Re: Edgewater proposal

To: Plan Commission Members
From: Peter Ostlind
Re: Edgewater Redevelopment Proposal
Date: February 4, 2010

Commentary on Edgewater UDC 1/20/10 and 2/3/10 Submissions and Handout

Subject: Edgewater Hotel Redevelopment

Proposed Green Space @ 1" = 40'
 The Edgewater Reconsidered
 December 2, 2009

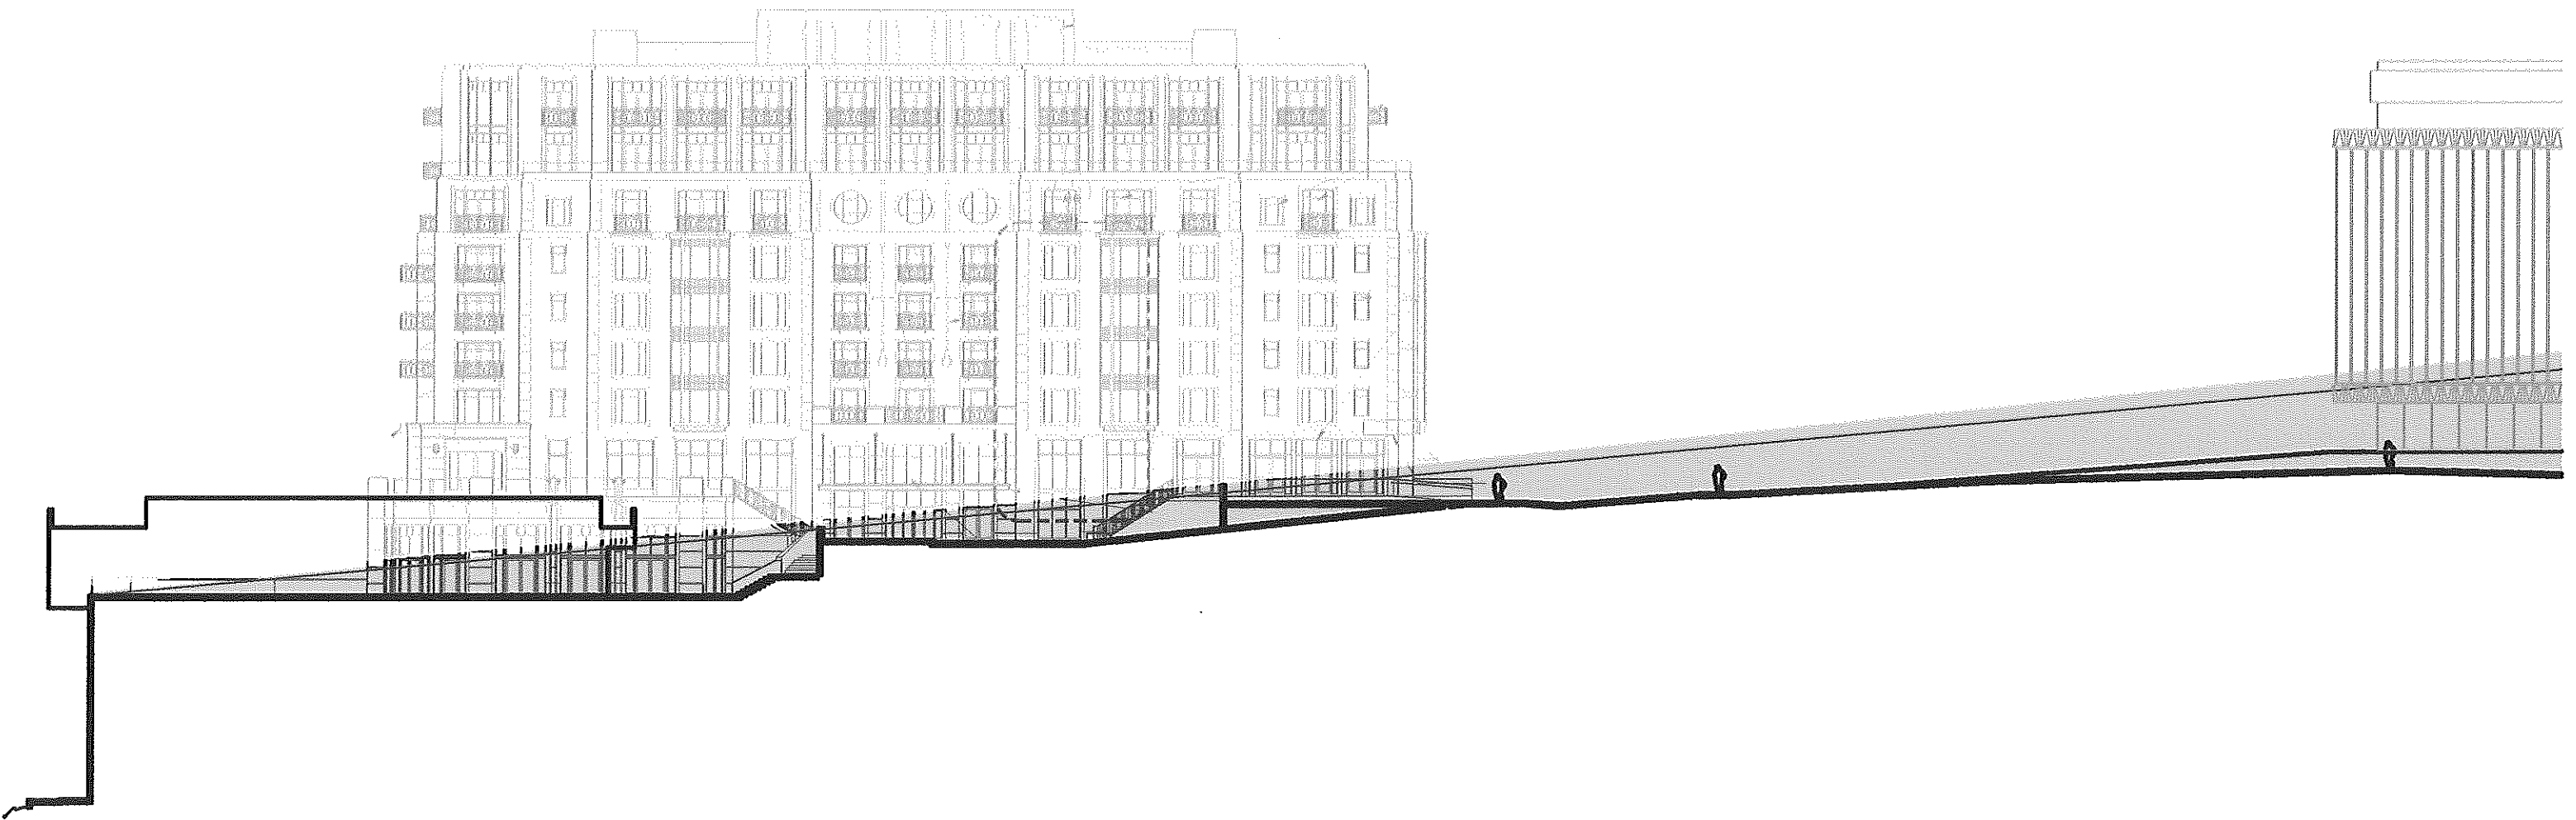
Green Space - Existing: 27,320 SF
 Green Space - Proposed: 2,360
 Green Space Lost: 24,960 SF

Proposed Green Space
 Within Project Area 13,430 SF
 Outside Project Area (NGL) 2,130
 Added
 Lost (13,200)
 Net 2,360 SF
